Barry Township T 1 N R 9 W Barry County Michigan

Section 6 08-03-006- Scale 1" = 400'

This tax map was compiled for tax administration purposes from county and township records. It does not represent a land survey.
Barry County Land Information Services
220 West State Street, Hastings MI 49058
(269) 945-1292 or <http://www.barrycounty.org/>

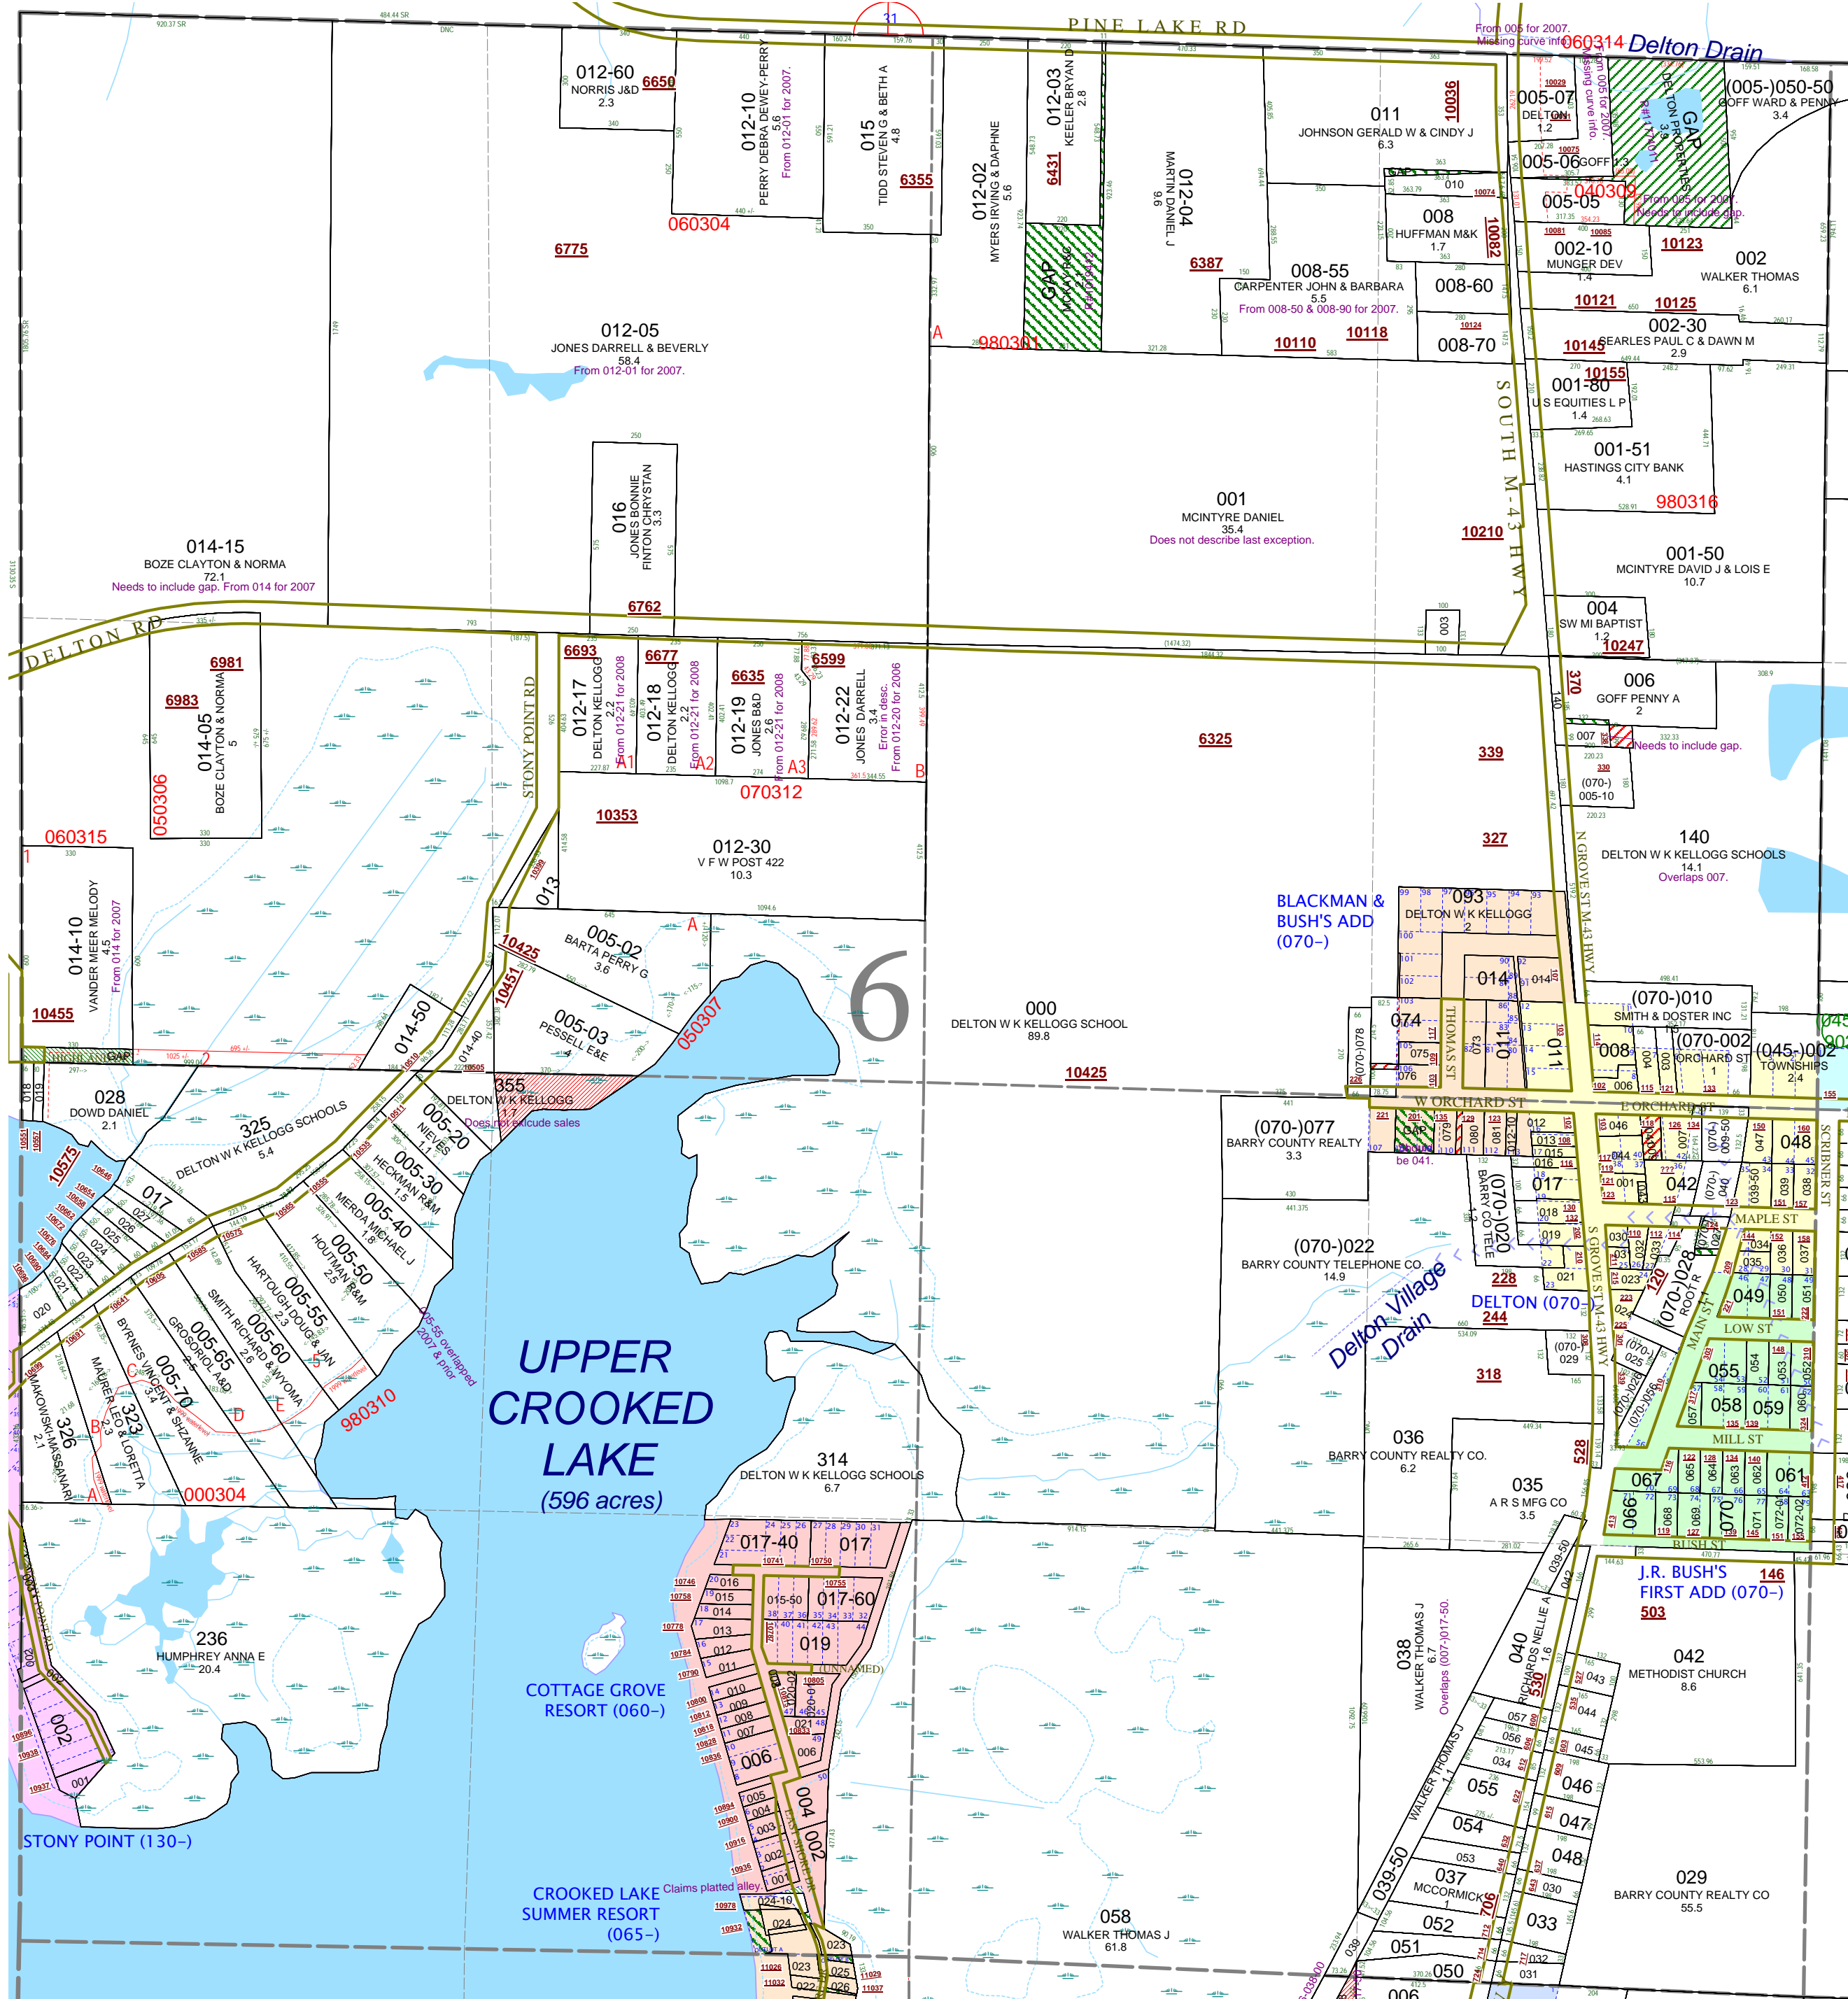
08-03-006-014-15 needs to include gap parcel south of 014-10.

08-03-006-012-22 overlaps 012-19 as described and needs to be new survey of remainder from split #070312.

08-03-006-014-40 was resurveyed and needs to include remainder from 355-00 after sale in R#1133709. The school filed a quit claim in R#1167099 to combine the remainder with 014-40. I suggest this record be deleted and 014-40 revised as above.

08-03-006-355-00 overlaps 005-03. The school filed a quit claim in R#1167099 to combine the remainder with 014-40. I suggest this record be deleted and 014-40 revised as above.

08-03-006-020-00 has a point of beginning error which should be SE corner lot 37 of Stony Point.

GAP east of lot 18 owned by Annie E. Humphrey as proprietor.

GAP east of lot 17 owned by Lawrence & Beverley Wrubel in L.696-738.

GAP east of lot 16 owned by Annie E. Humphrey as proprietor.

08-03-130-002-00 overlaps 08-12-490-002-00 & 001-00 and needs to indicate that it is lots 2 thru 9 inclusive.

08-03-060-001-00 needs to include gap parcel to its south deeded in L.659-244.

08-03-065-024-00 needs to include parcel deeded in L.475-288 & L.659-243 lying easterly of current lot. It also seems to overlap 024-10 because they dropped an exception between deed L.352-527 & 456-601 by using what appears to be a tax description on a family transfer.

08-03-065-024-10 is missing direction in two courses. See #20080109000298.

08-03-065-023-00 needs to include lake front parcel (left off R#1008351).

08-03-006-005-07 is missing its curve information. See split #060314.

GAP which is remainder of 005-00 owned by Delton Properties in R#11774011.

08-03-006-005-06 is missing its curve information. See split #060314.

GAP between 011 & 010 owned by Elihue & Wilma Elizabeth Holston in L.361-499.

08-03-006-005-05 needs to include part of gap parcel and needs to be described as deeded in R#1135063.

GAP deeded to Robert & Cheryl McKay in R#1019412 and withheld in sale to Keeler in R#1036788. Planning & Zoning said this property was supposed to be deeded to Martin in 1999.

08-03-006-001-00 needs to describe last exception as deeded to MDOT in R#1180510.

08-03-006-007-00 overlaps 140 and needs to include gap parcel to north. See R#1165326. 08-03-006-140-00 needs to exclude parcel deeded to Chapple Realty in R#1089037

08-03-070-074-00 overlaps 076 by 1 rod, both with deeds to the overlap. This overlap though, cuts into the garage on Orchard Street.

08-03-070-076-00 needs to exclude platted alley.

08-03-070-041-00 is describing the wrong property and should be over in the Blackman & Bush's Addition.

08-03-070-079-00 overlaps 080 and has wrong plat name.

08-03-070-080-00 has the wrong plat name.

08-03-070-051-00 has the wrong plat name.

08-03-070-052-00 has the wrong plat name.

08-03-070-054-00 has the wrong plat name.

08-03-070-056-00 has the wrong plat name.

08-03-070-072-01 has the wrong plat name.

08-03-070-072-02 has the wrong plat name.

08-03-006-054-00 needs to add "T1N R9W" after first section number.

08-03-006-033-00 has a typo change 145.5 to 145.6 in last course.

08-03-006-038-00 overlaps 03-007-017-50 and is in two pieces in two separate sections.
